Los Angeles International Airport

# **Second Addendum to the Environmental Impact Report for the Los Angeles International Airport Landside Access Modernization Program**

Los Angeles World Airports

**RICONDO**

**EXHIBIT 3**

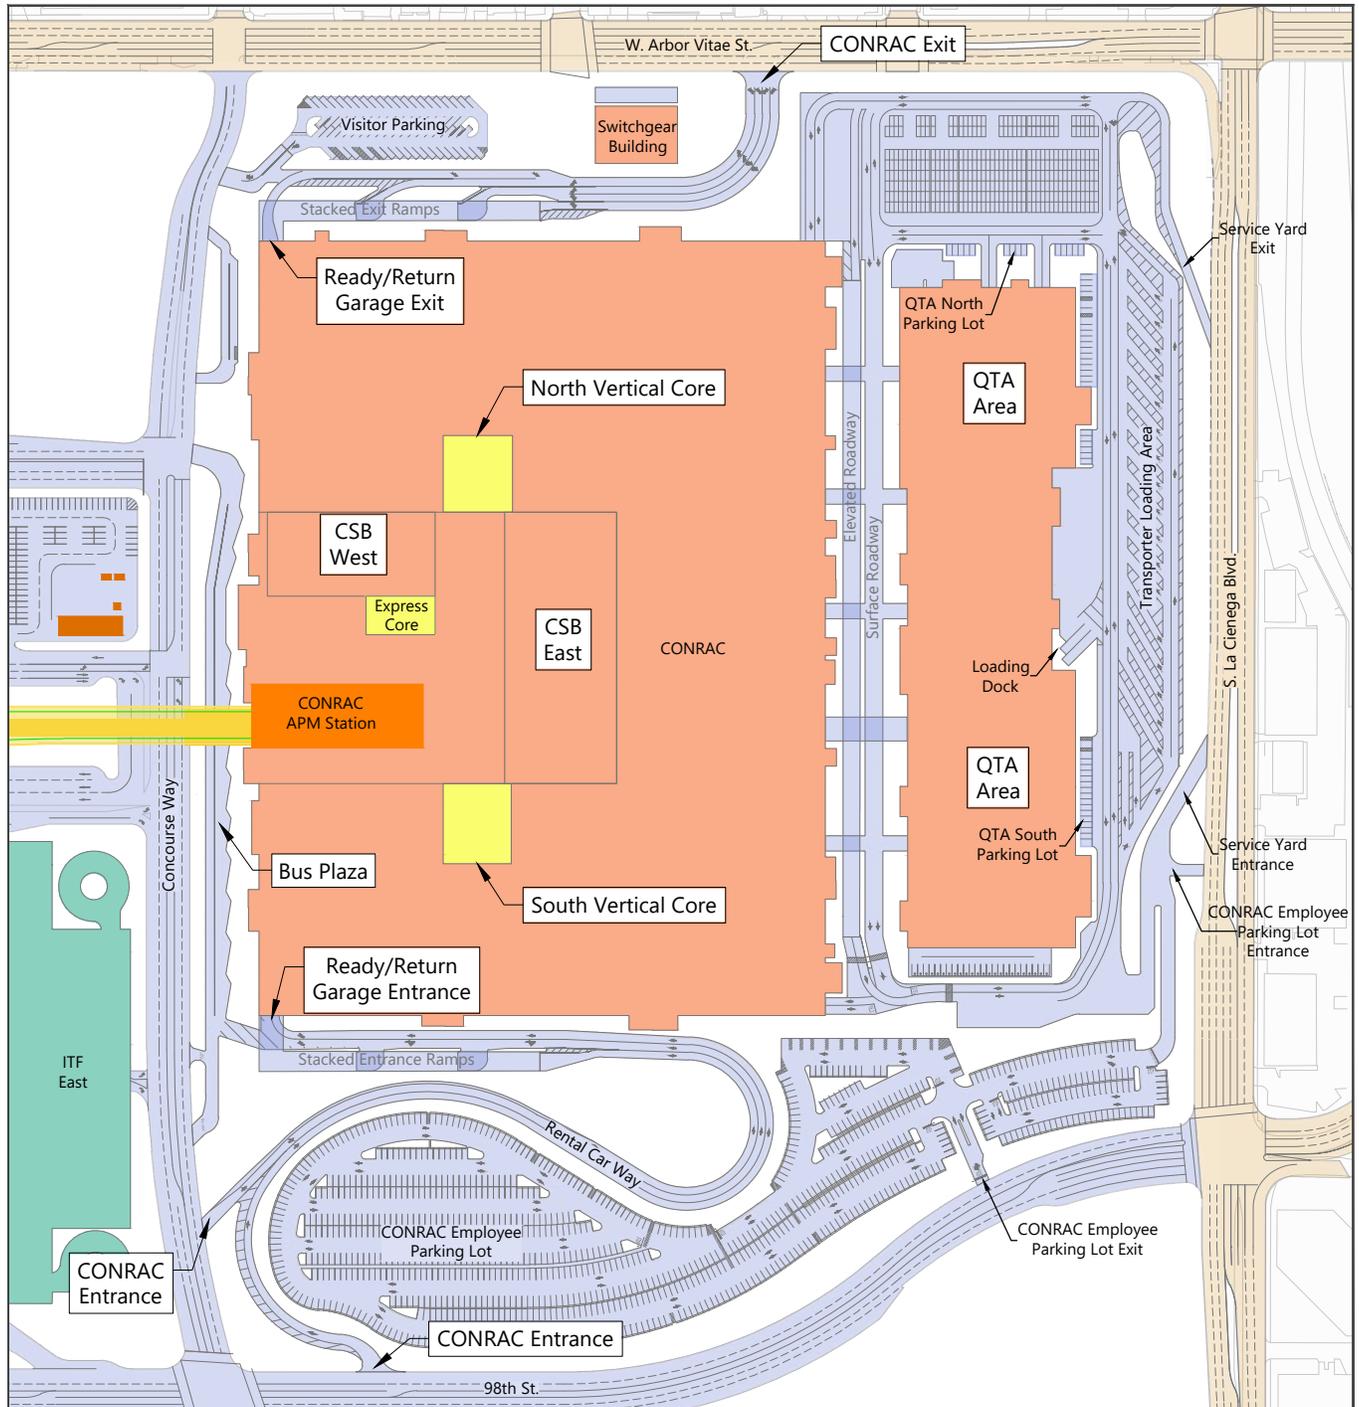
The modified CONRAC will have three to five levels with an estimated elevation of 60 to 85 feet above ground level. As shown in **Table 1**, the modified CONRAC will have a footprint of approximately 1,108,000 square feet and a total floor space of approximately 5,719,000 square feet. The footprint and total floorspace of the modified CONRAC are 992,000 square feet smaller and 281,000 square feet smaller than the approved CONRAC, respectively. The modified CONRAC is shown on **Exhibit 4**.

The vehicle entrance to the approved CONRAC was to be at the southwest corner of the Ready/Return garage. To access the CONRAC entrance from the east, employees and visitors were to drive west along W. 98th Street past S. La Cienega Boulevard and merge right (north) onto a driveway to an internal circulation road that was to provide access to the CONRAC entrance. To access the CONRAC entrance from the west, employees and visitors were to drive east along W. 98th Street past Concourse Way and merge right onto an underpass that was to be constructed beneath W. 98th Street between Concourse Way and S. La Cienega Boulevard. The CONRAC vehicle exit was to be at the northwest corner of the Ready/Return garage onto an internal circulation road. A signalized intersection at the internal circulation road and W. Arbor Vitae Street was to allow vehicles to make right or left turns onto W. Arbor Vitae Street. No northbound or through movements from the internal circulation road to north of W. Arbor Vitae Street were to be allowed.

Under the Modifications, access to the CONRAC has been modified through the refinement process and discussions with the City of Los Angeles Department of Transportation and City of Inglewood. As shown on Exhibit 4, the vehicle entrance to the CONRAC will be at the southwest corner of the modified CONRAC. An internal circulation road (Rental Car Way) will provide access to the modified CONRAC. To access the CONRAC from the east, customers and employees will drive west along W. 98th Street and merge right (north) onto a driveway to Rental Car Way. To access the CONRAC from the west, customers and LAWA employees will drive east along W. 98th Street and turn left (north) at Concourse Way and merge right (east) onto a driveway to Rental Car Way. Under the Modifications, all CONRAC access will occur at street level; therefore, the underpass beneath W. 98th Street that was identified and analyzed in the certified Final EIR will not be constructed.

**EXHIBIT 5**

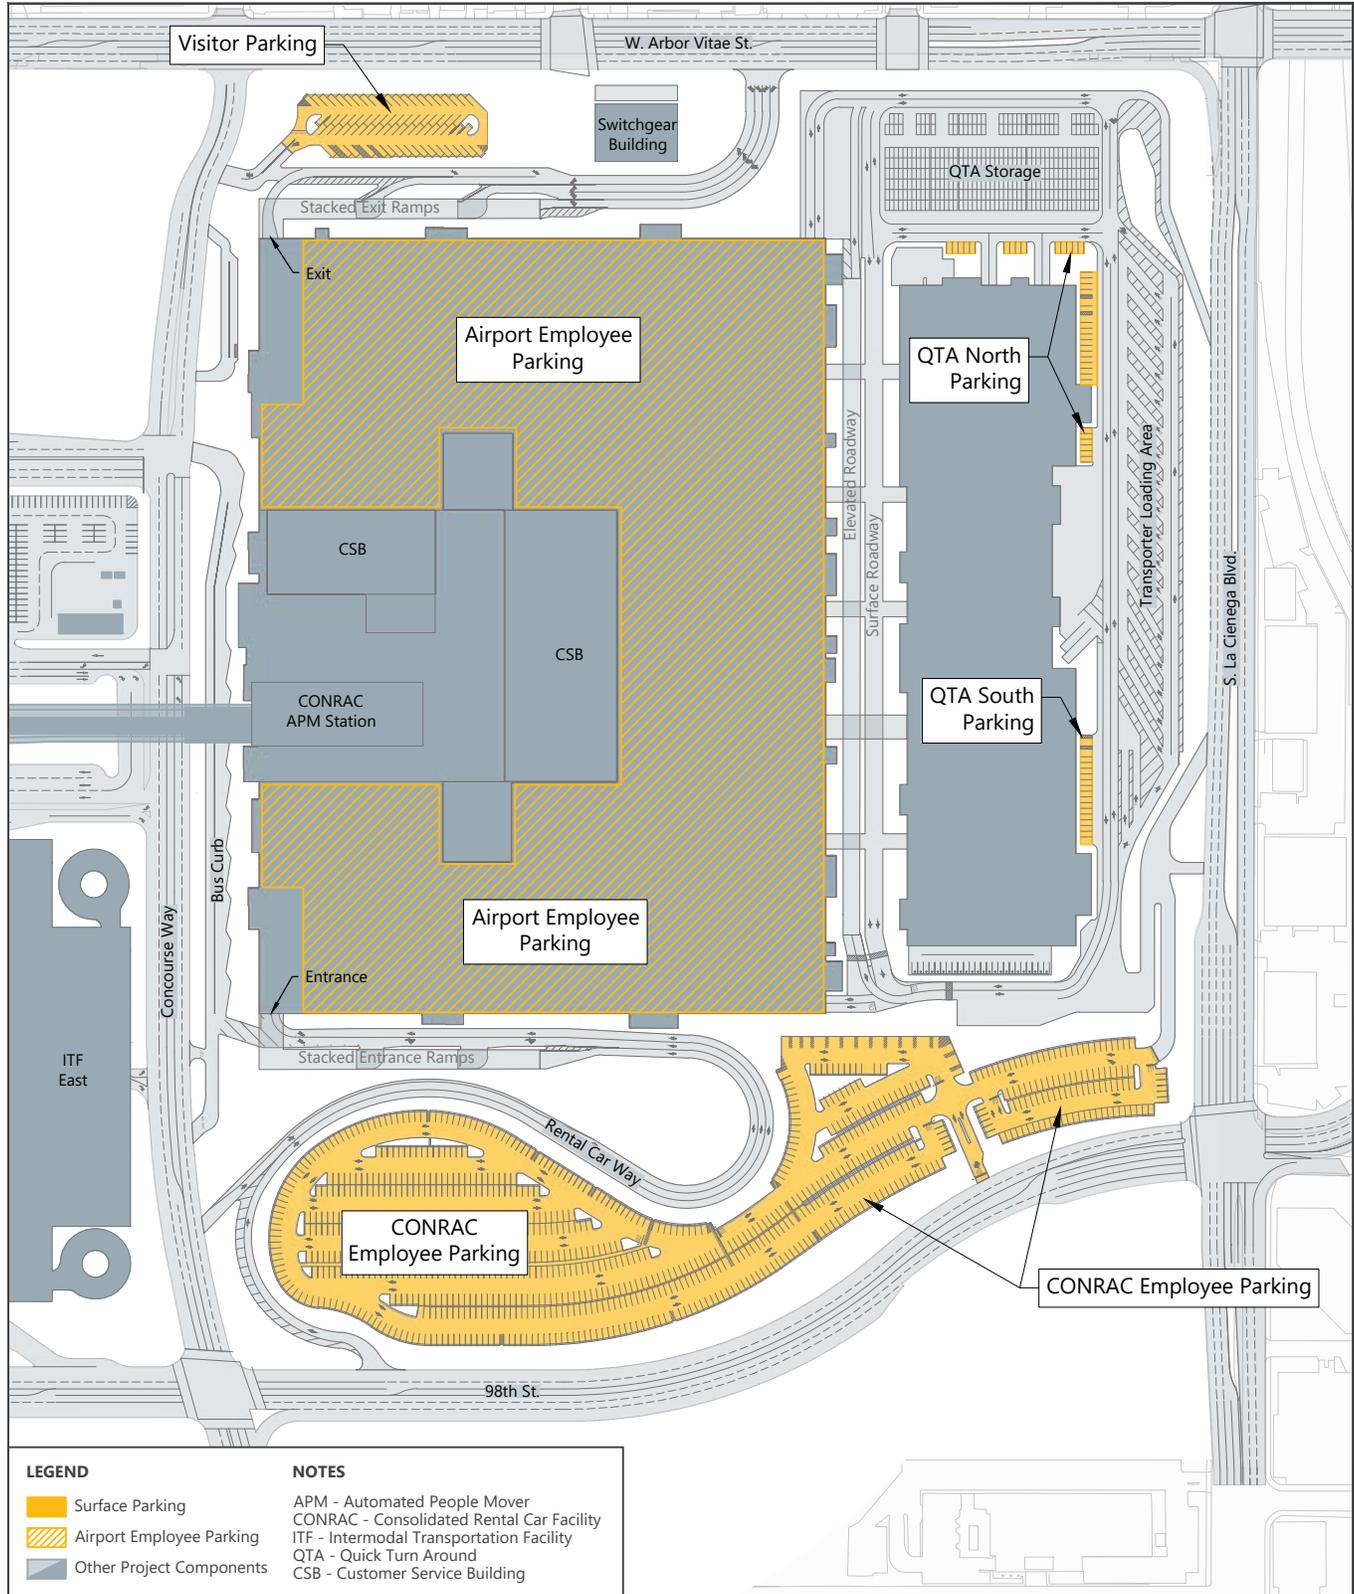
In order to accommodate the implementation of a signalized intersection at the modified exit driveway and W. Arbor Vitae Street, modifications will be made to the private property on which the Mariscos El Puerto Escondido Restaurant (Mariscos Restaurant) is a tenant, and which is located opposite (north of) the CONRAC exit driveway. The private property, Los Angeles County Assessor parcel number 4126-014-051 located at 915 W. Arbor Vitae Street, Inglewood, is approximately 0.18-acre in size and comprises Mariscos Restaurant and associated parking.

**Exhibit 5** shows the modifications to the private property.

**EXHIBIT 7**  
**MODIFICATIONS - LOCATION OF POWER SUBSTATIONS**

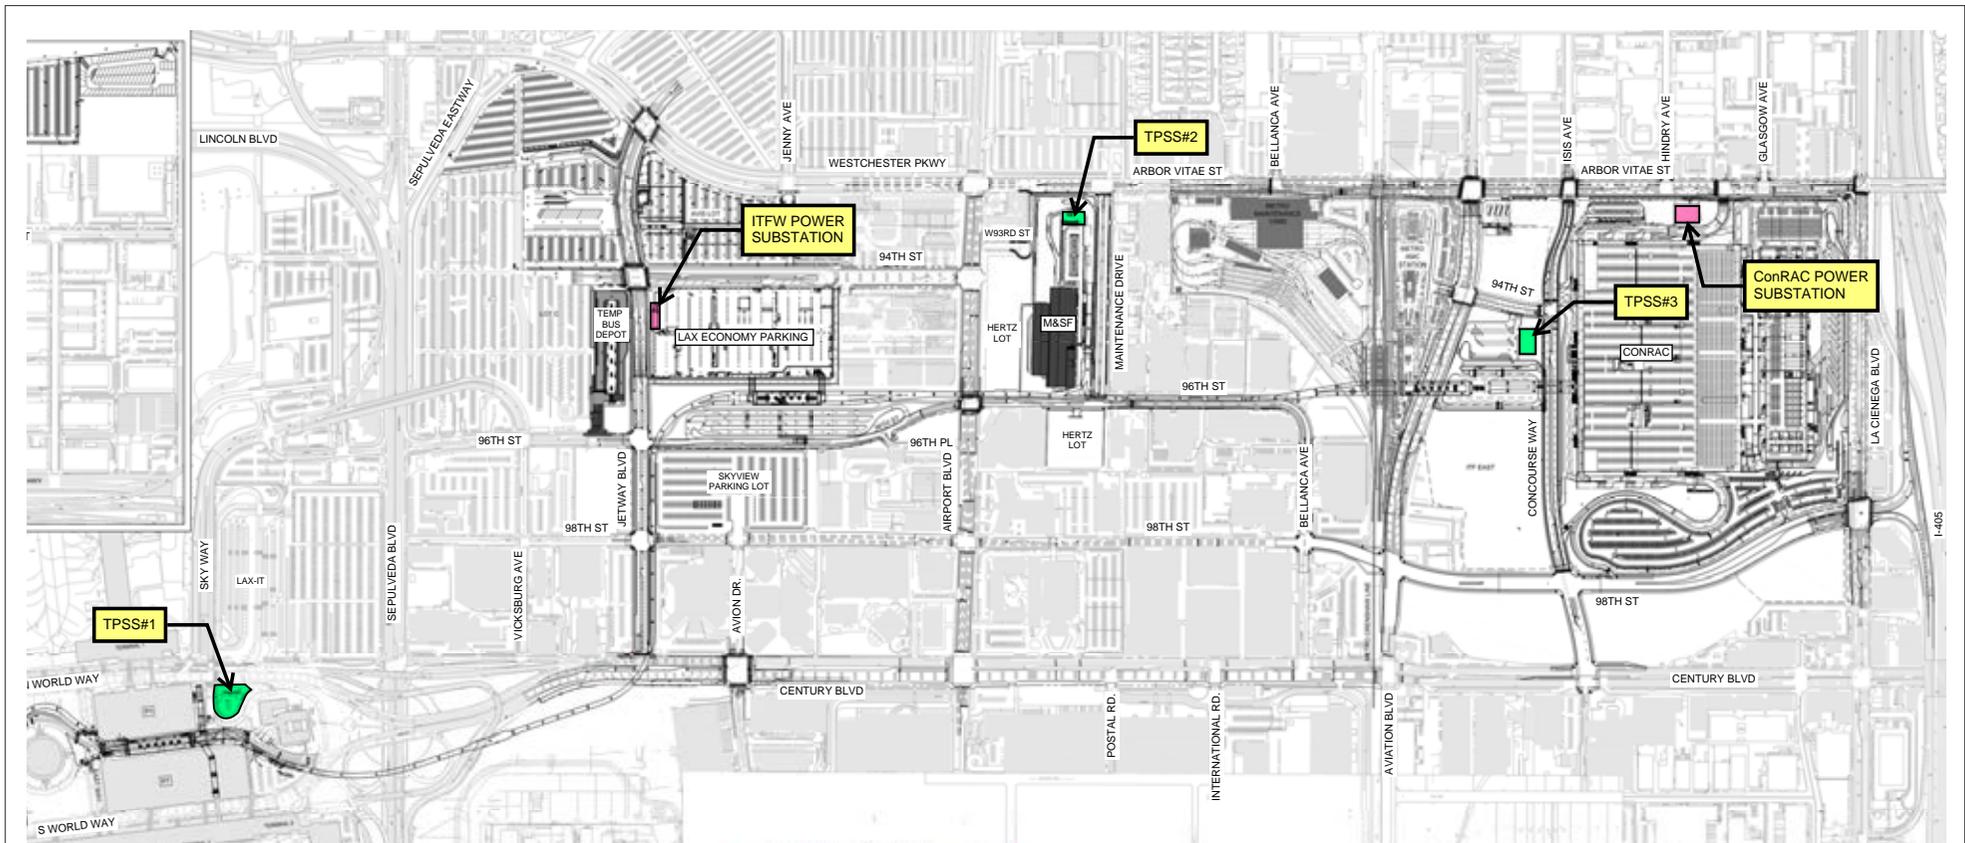
The approved Project was to include up to four TPSSs to provide power to the APM guideway and trains as well as LADWP electrical industrial stations to supply power at the APM MSF and the CONRAC. Under the Modifications, the number and location of these substations has been modified through the refinement process (see **Exhibit 7**).

- The certified Final EIR considered a CTA TPSS that was to be located adjacent to World Way, south of the 1961 Airport Traffic Control Tower (ATCT) and Clifton A. Moore Administration Building. Under the Modifications, a TPSS will be located in the CTA adjacent to World Way, west of the 1961 ATCT and Clifton A. Moore Administration Building. The entire area for the TPSS in the CTA will be up to approximately

- The certified Final EIR considered an ITF West TPSS that was to be located directly west of the W. 96<sup>th</sup> Street / Airport Boulevard intersection, approximately 270 feet west of Airport Boulevard and 640 feet north of W. 98<sup>th</sup> Street. Under the Modifications, this TPSS will not be constructed.

- The certified Final EIR considered an ITF East / CONRAC TPSS that was to be located north of the APM guideway, between the ITF East APM station and the CONRAC APM Station. The facility was to be located approximately 380 feet east of Aviation Boulevard and approximately 860 feet south of W. Arbor Vitae Street. Under the Modifications, a TPSS will be constructed in a similar location. The entire area for the TPSS near the ITF East / CONRAC will be up to approximately 8,000 square feet, including the TPSS and additional support equipment.

- The certified Final EIR considered a TPSS that, if needed, could be located adjacent to the APM MSF. Under the Modifications, a TPSS will be constructed north of the APM MSF approximately 100 feet south of W. Arbor Vitae Street. The entire area for the TPSS near the APM MSF will be up to approximately 11,400 square feet, including the TPSS and additional support equipment.

- The certified Final EIR considered LADWP electrical industrial stations to supply power at the APM MSF and the CONRAC at undetermined locations. Under the Modifications, a CONRAC power substation will be located north of the CONRAC and directly southeast of the W. Arbor Vitae Street / Hindry Avenue intersection. A second electrical industrial station will be located on the western end of the ITF West (which is also the location of the LAX Economy Parking structure) directly east of Jetway Boulevard (referred to as "New 'A' Street" in the certified Final EIR) and approximately 600 feet north of W. 96<sup>th</sup> Street.
